# Access Compliance Report

## Public Rights-of-Way

### (Curb Ramps)

Intersection ID: 48394	Main Street: RICHARD_ROZZELLE_DR	Cross Street: SUSANNA_DR	Location:	N
ADA ID: 9D73A768DE03	Ramp Type: Perp	Initial Pass/Fail: Fail	Overall Compliance: No	Severity Score: 10
Codes/Mitigation Info/Possible Solution		Field Measurements/Component Compliance

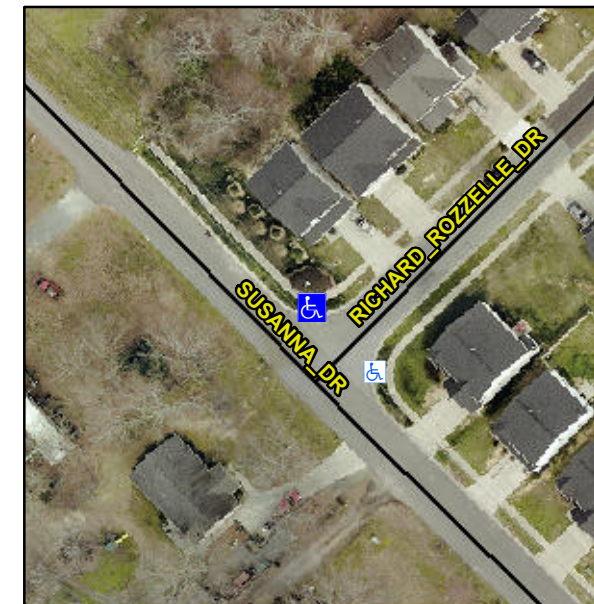
**Not Found, R304.5.1, R304.5.3**

Compliance	Description	Data	Compliance	Description	Data
N/A	Ramp Length (in)	72.0	Yes	Ramp Slope (%)	5.0
No	Ramp Width (in)	47.5	No	Ramp XSlope (%)	2.8
N/A	Flare Type LT	N/A	N/A	Flare Type RT	N/A
N/A	Flare Slope LT (%)	N/A	N/A	Flare Slope RT (%)	N/A
N/A	Flare Traversable LT?	N/A	N/A	Flare Traversable RT?	N/A
N/A	Landing Length (in)	N/A	N/A	DWS Provided?	N/A
N/A	Landing Width (in)	N/A	N/A	DWS Contrast?	N/A
N/A	Landing Slope (%)	N/A	N/A	DWS Length (in)	N/A
N/A	Landing X Slope (%)	N/A	N/A	DWS Full Width?	N/A
N/A	Landing Curb? (Y/N)	N/A	N/A	DWS Offset (in)	N/A
N/A	Shared Landing?	N/A			
N/A	Gutter Ponding?	N/A	N/A	Gutter Slope (%)	N/A
N/A	Gutter Lip Ht (in)	N/A	N/A	Gutter X Slope (%)	N/A
N/A	Painted X Walk1?	No	N/A	Painted X Walk2?	N/A
	X Walk 1 Direction	To SE		X Walk 2 Direction	N/A
N/A	X Walk 1 Width (in)	N/A	N/A	X Walk 2 Width (in)	N/A
	X Walk 1 Slope (%)	2.3		X Walk 2 Slope (%)	N/A
	X Walk 1 X Slope (%)	2.1		X Walk 2 X Slope (%)	N/A

**Remove & Replace Entire Ramp.**
